**MALTESE POINT -
ROLLING THUNDER
PEYTON, CO**

SHEET TITLE:
LANDSCAPE PLAN

PCD FILE NO.
PPR 2414

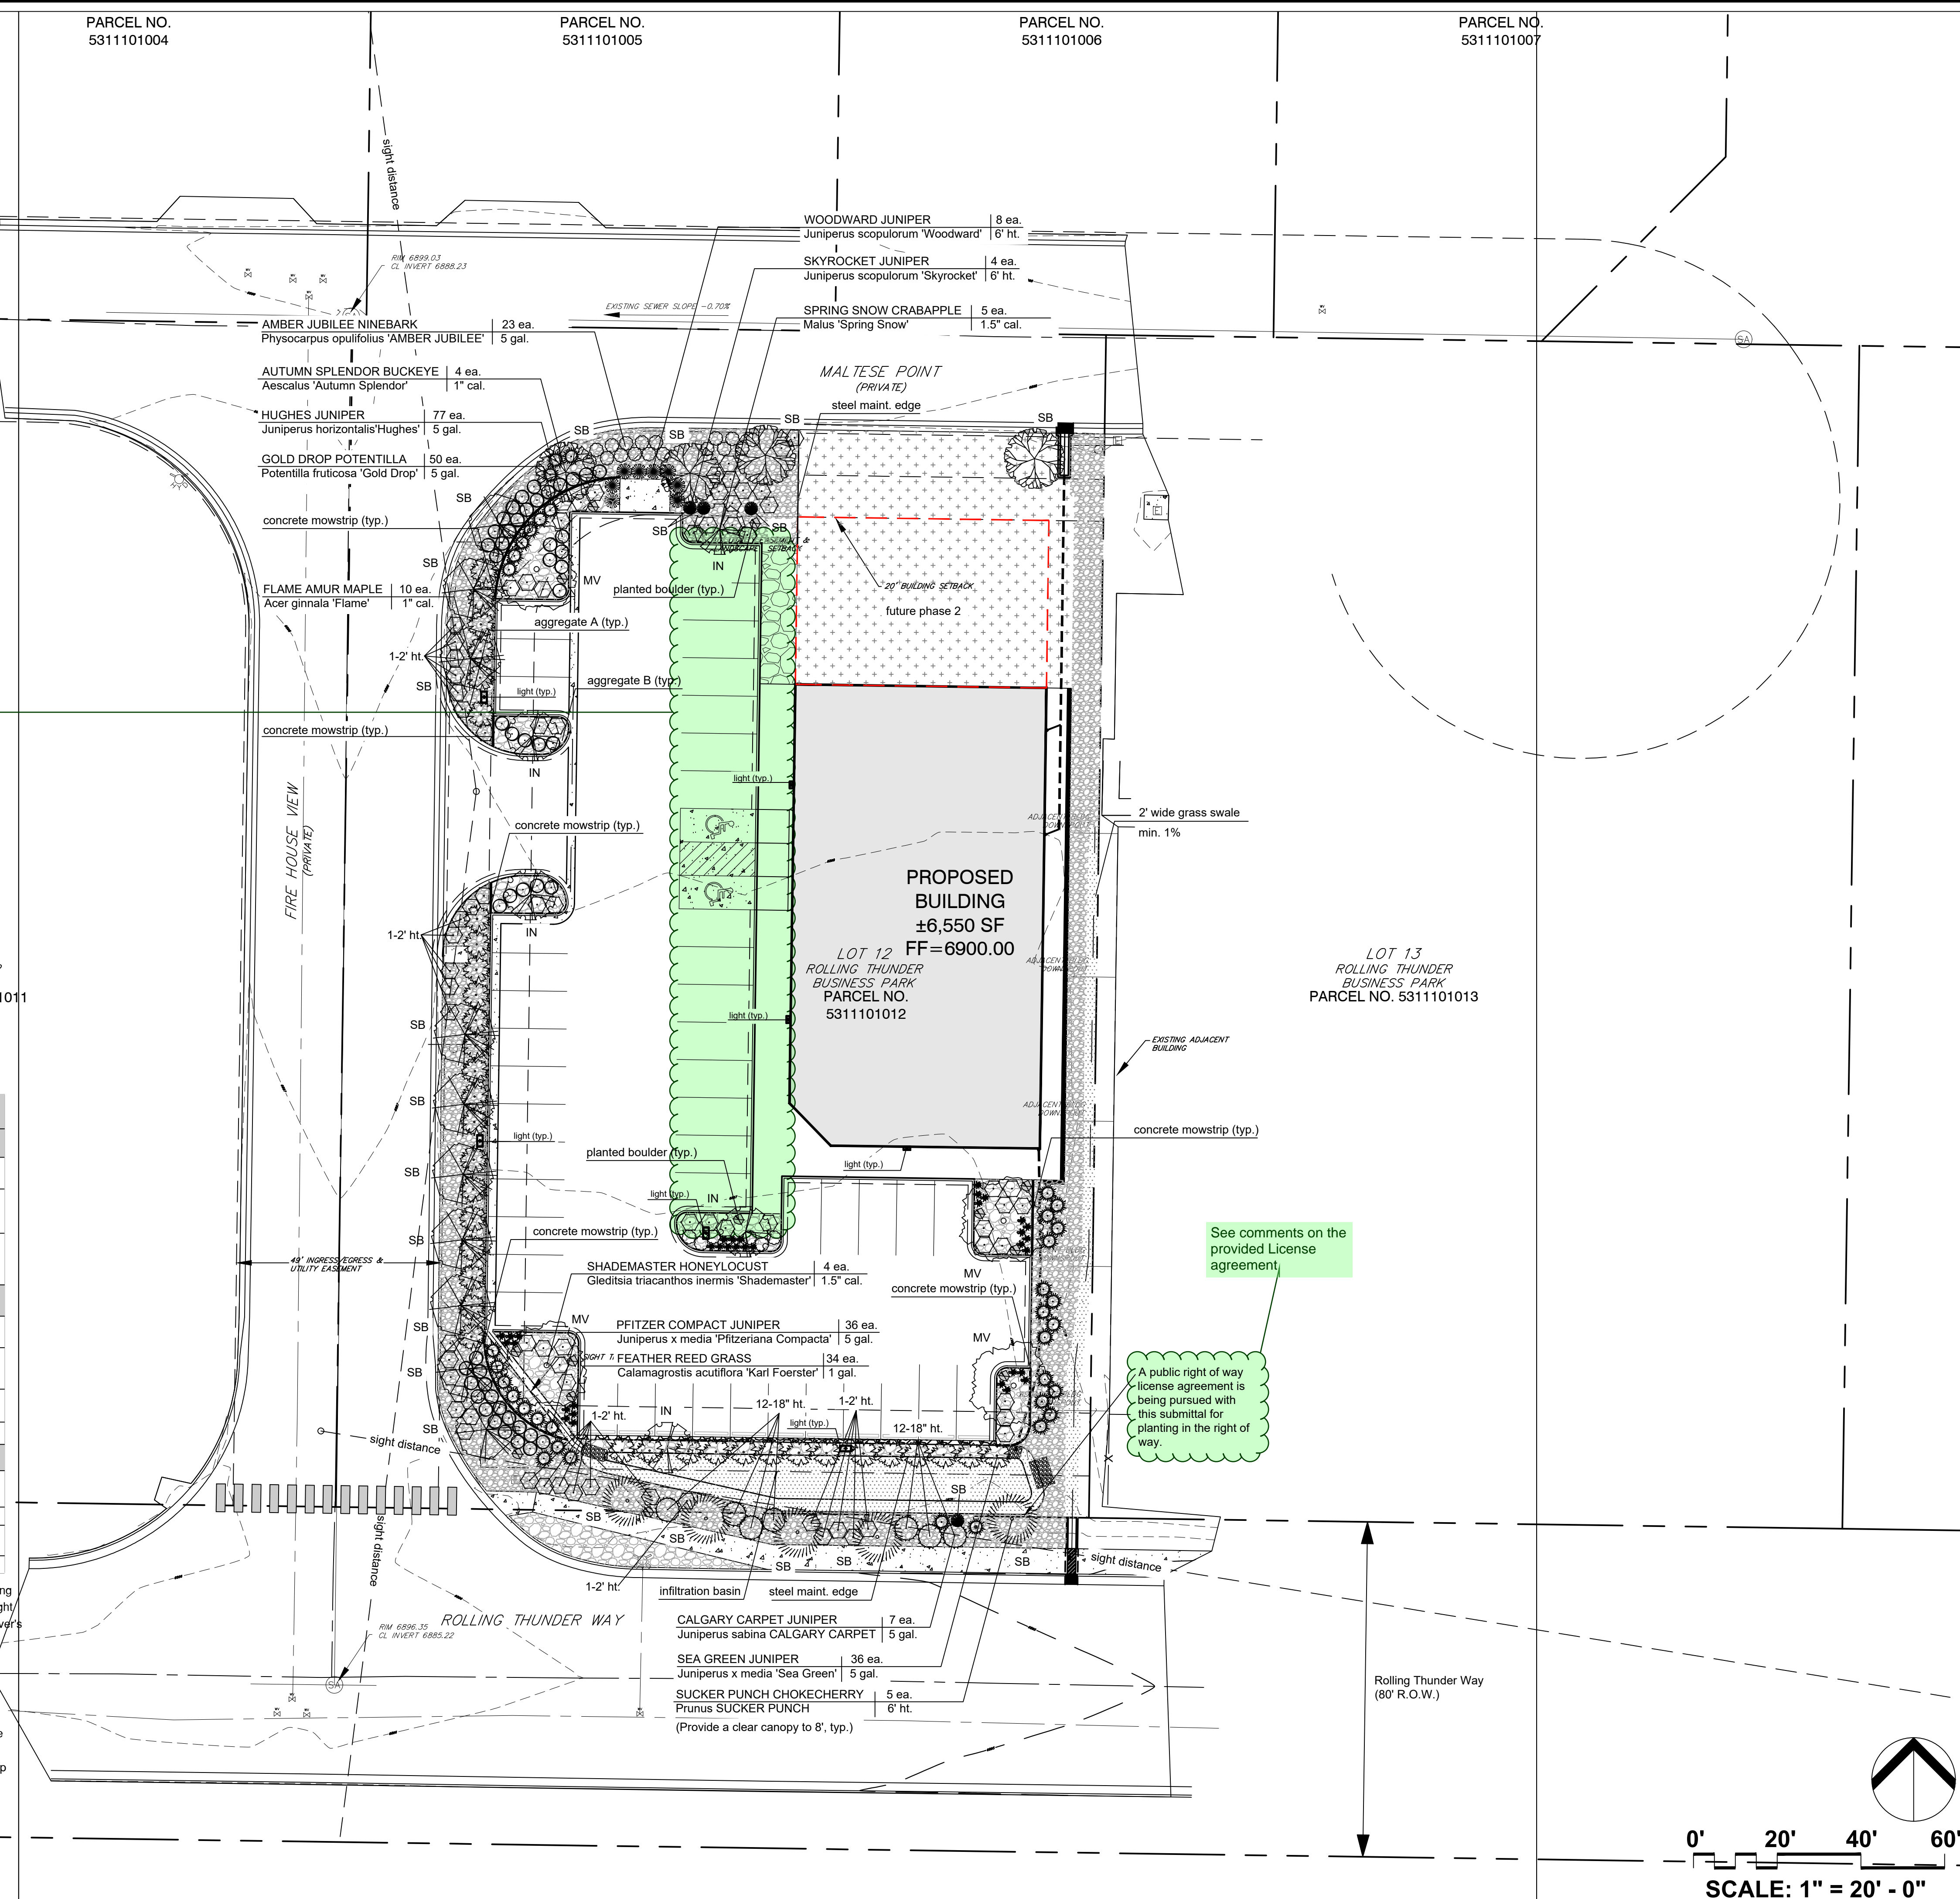
Per Section 6.2.2.C.1. "A tree of a type suitable for parking lots shall be provided for every 15 parking spaces in parking lots with 15 or more parking spaces. The required trees may be clustered and shall be located in a manner which will divide and break up expanses of paving and long rows of parking and create a canopy effect over the parking lot."

Per Section 6.2.2.C.2. "The most common method to satisfy the parking lot tree requirement is through the utilization of plant islands, fingers (areas open to the parking on 3 sides), and corners (open to the parking on 2 sides). Islands, fingers, and corners are required to be incorporated into all parking lots of 15 parking spaces or more in area. 1 island shall be provided for every 15 spaces. An island, finger or corner must be a minimum of two parking spaces in size (18' x 18' or 9' x 36' in order to qualify as a required island, finger, or corner."

See comments on the provided License agreement

This will need to be shown prior to approval, most specifically for the landscaped area within the right of way

Re. driveway exiting into Fire House View: per Table 2-35 of the El Paso County Engineering Criteria Manual (ECM), the entering sight distance for a two lane roadway with a posted speed of 25 miles per hour is 250 feet. For calculating sight distance, a height of 3.5 feet is used for the driver's eyes at the access location and a height of 3.5 feet for the oncoming vehicle. The entering driver's eyes shall be 10 feet behind the edge of the roadway. These criteria are found in 2.4 Roadway Access Design of the ECM. Pursuant to 2.3.6.G.2, the proposed shrubs within the sight distance triangle have a mature height of 1' to 2'. This is under the threshold of 30" above the flowline elevation of the adjacent roadway.

Re. driveway exiting south from Fire House View to Rolling Thunder Way: per Table 2-21 of the El Paso County Engineering Criteria Manual (ECM), the intersection sight distance is measured from a point on the minor road at 13 feet back from the edge of the major road pavement and measured from a height of eye at 3.5 feet on the minor road to a height of object at 3.5 feet on the major road. In this case, the sight distance was derived from a point 13 back from the pedestrian marker striping and stop sign. The posted speed of the road is 35 m.p.h., so a distance of 390 feet was interpolated between the value of 335 feet at 30 m.p.h. and 445 feet at 40 m.p.h.

A public right of way license agreement is being pursued with this submittal for planting in the right of way.
